DAIMLER CHRYSLER

Customer Satisfaction Campaign – Rectification of possible water seepage in passenger compartment – W 203

To eliminate a chance of water seepage through sealant on W203

TPA WI 13.1.27

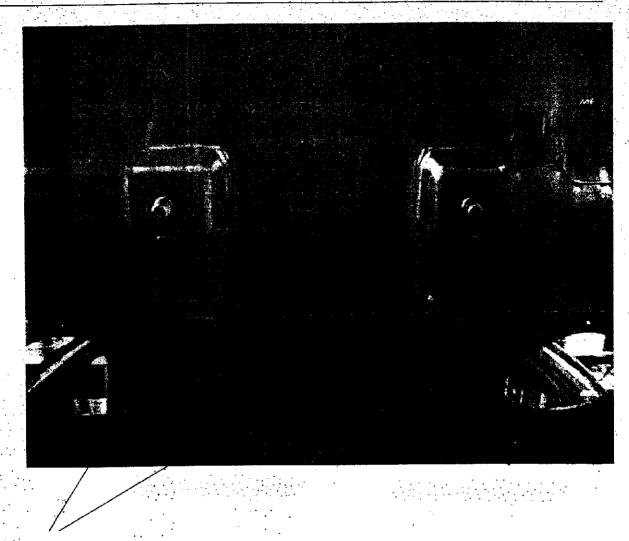
The photograph is taken on a cab from below the floor on a cab Application of sealant to be done at the open edge of these plates

5 Apply the sealant on LH & RH side
Use the sealant with equal proportion of
Part No.: A 000 989 7220
A 000 989 7520

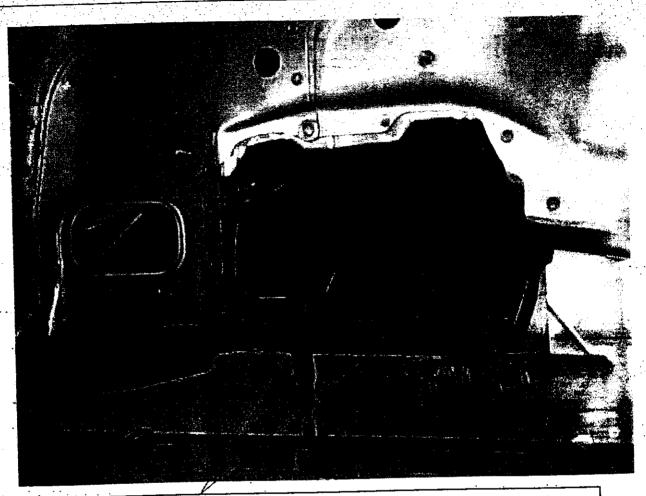
Application of sealant along the open edges of the plates
